EXECUTIVE ORDER D-1-3  
Relating to Exemptions under Section 27156  
of the Vehicle Code

CONTIGNITRON COMPANY  
"MODEL 46", "MODEL 48" and "MODEL 48C"

Staff Report

Evaluation of the Contignitron  
Company's Request to Modify  
its "Model 48" Oxides of Nitrogen  
Control Device for 1966-70 Model-  
Year Chrysler Vehicle Applications

Figure 1  
Centrifugal Spark  
Advance Curves  
1970 Plymouth

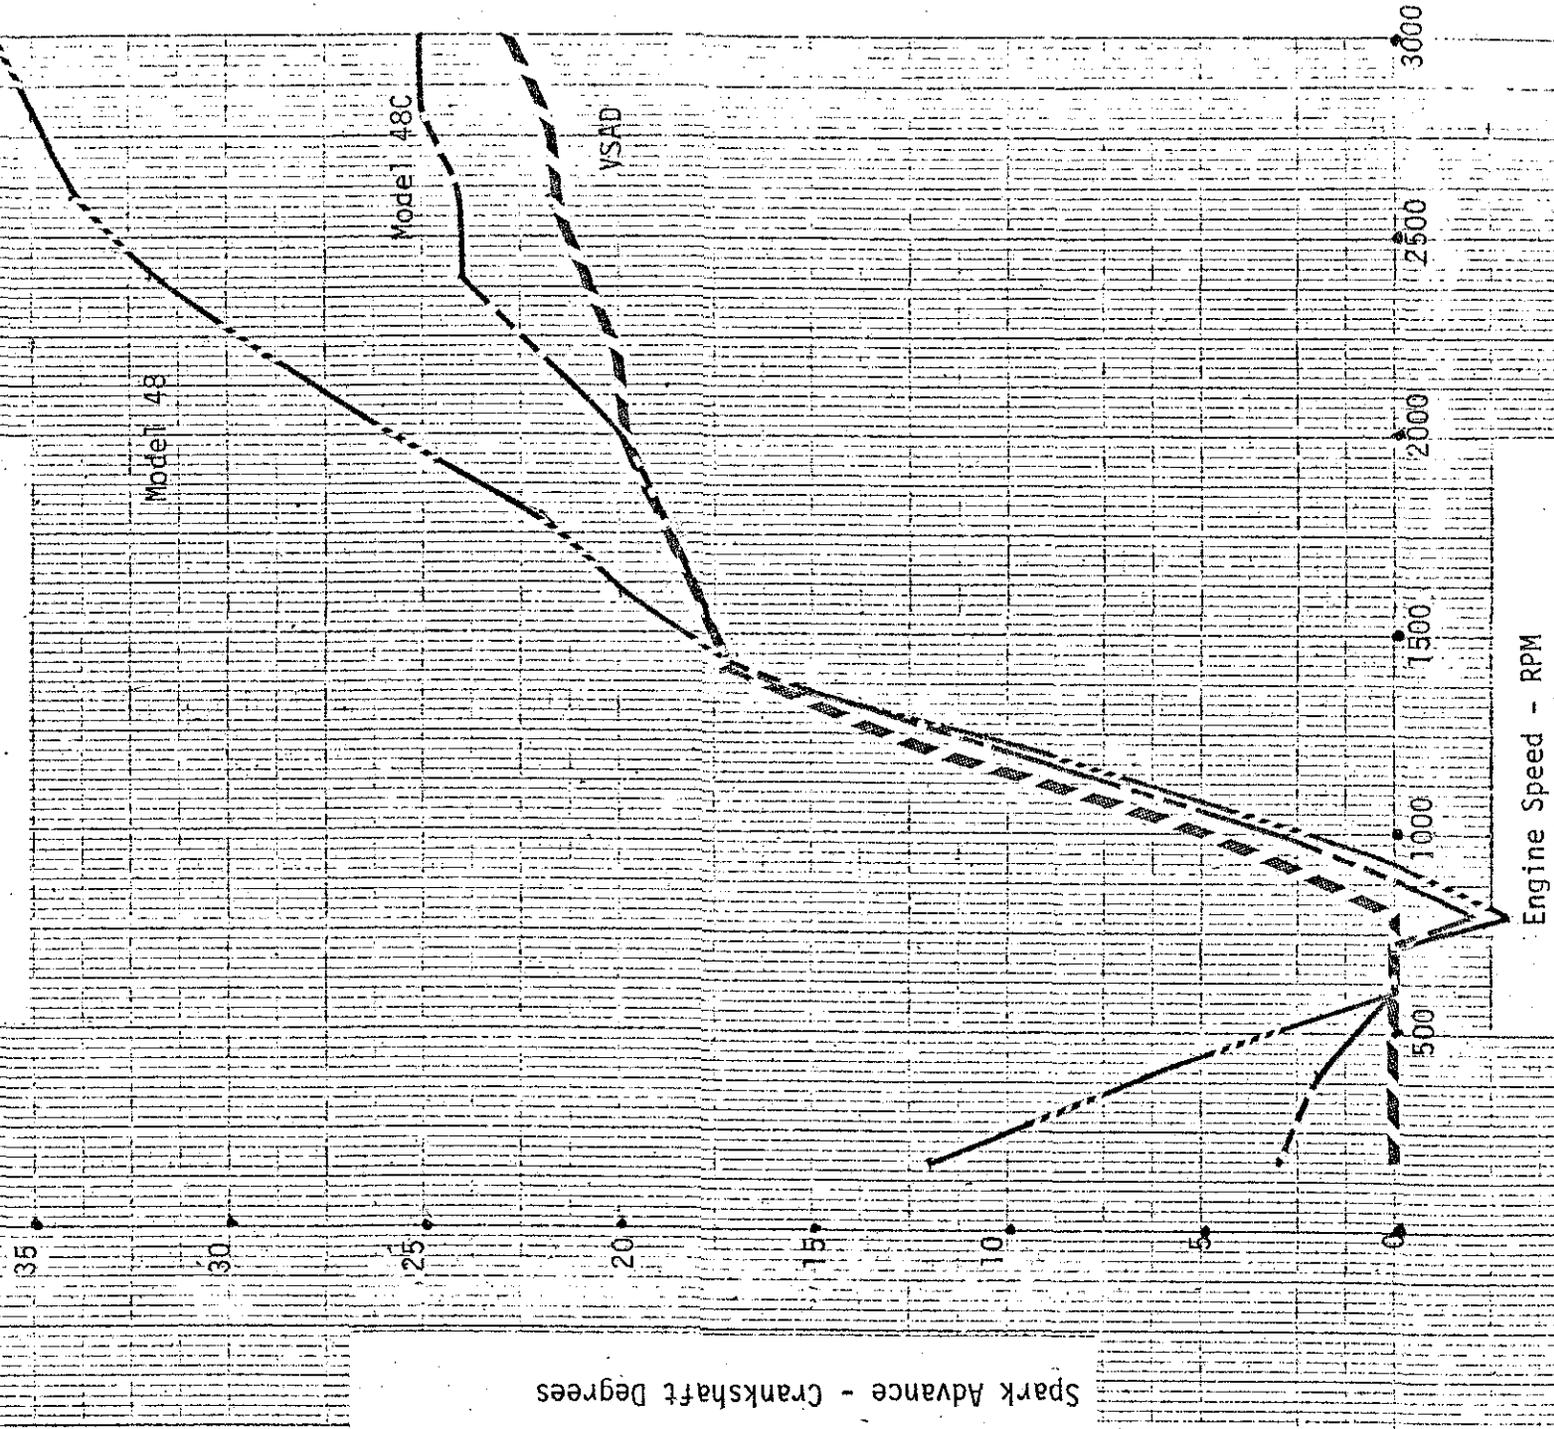
Sixty-two of the 68 demerits noted in the tests of the Model 48 device were the result of detonations. No demerits for detonations were detected with baseline vehicle or with the Model 48C device. VSAD, Model 48 and Model 48C device centrifugal advance curves are shown in Figures 1 and 2. These Figures show that the modifications have reduced the spark advance of the Model 48 device at the higher engine speeds to only approximately two degrees more advance than the centrifugal advance. The modifications have also limited the change in timing during starting conditions. The Model 48 device advances the spark by up to 12 degrees from the idle speed timing, whereas, the Model 48C device advances the timing by two degrees. The staff is of the opinion that the modified device has improved driveability by eliminating the detonation problem and improved starting conditions by reducing the device's effect on timing changes at these conditions.

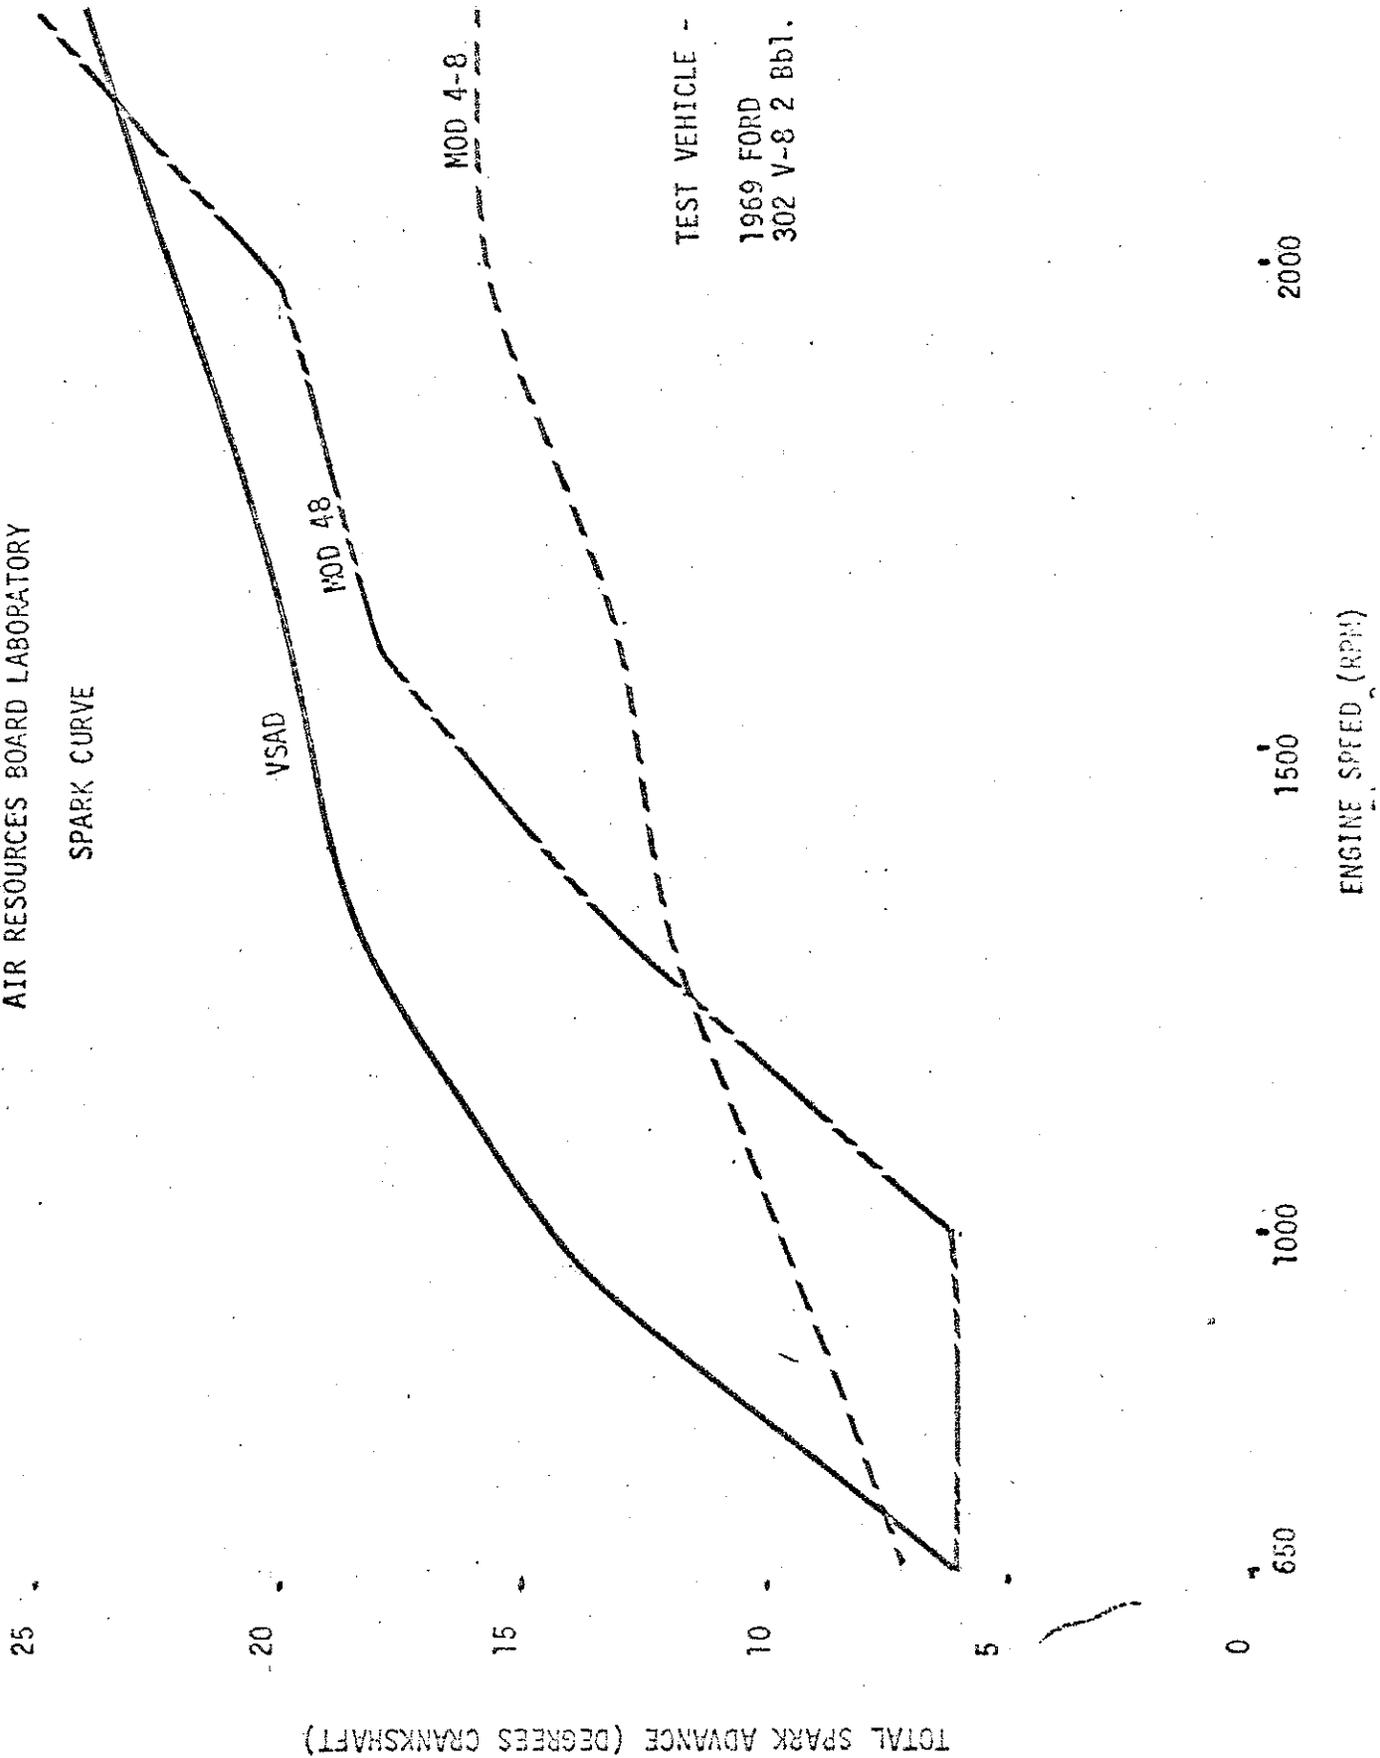
The initially accredited device, Model 4-8, was designed to produce up to six degrees of spark retard from the centrifugal advance curve. See Figure

3. Because of the concern expressed by the staff regarding the potential adverse temperature effects caused by this amount of spark retard, Contignitron requested approval to modify the device. The modified designs, Models 48 and 46, electronically restored up to 12 degrees of spark advance above the centrifugal advance curve at the higher engine speeds. See Figure 3 for the spark curve of the Model 48 device (used with 8-cylinder engines).
